Product Change Notification: PCN-23-172722

General Product Description:
MJ,LPF,R/A

Packaging change from EPS tray to PET soft tray

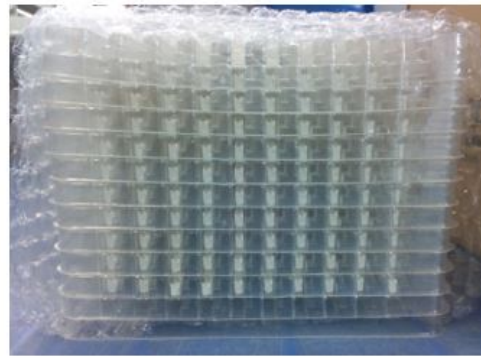
EPS tray Current Packaging

PET soft tray New Packaging

Photo:

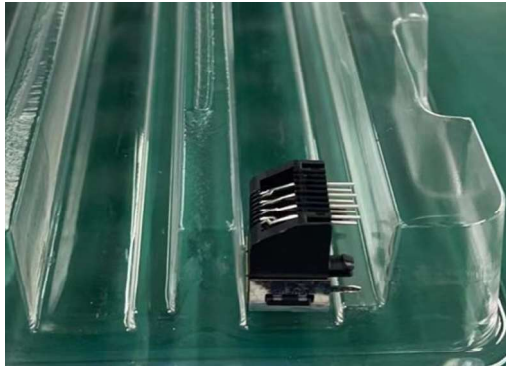
Pkg method: 114 pcs/Tray x7 =798 shipping box
 The detail packaging instruction is according to PS 107-107756 Rev B.
---Test result: There are no any products damaged and defect after drop test.
---The corner of shipping box impacted were distorted, but not damaged

0%, 0 pcs (NG) / 798 pcs (OK) : 1 BOX
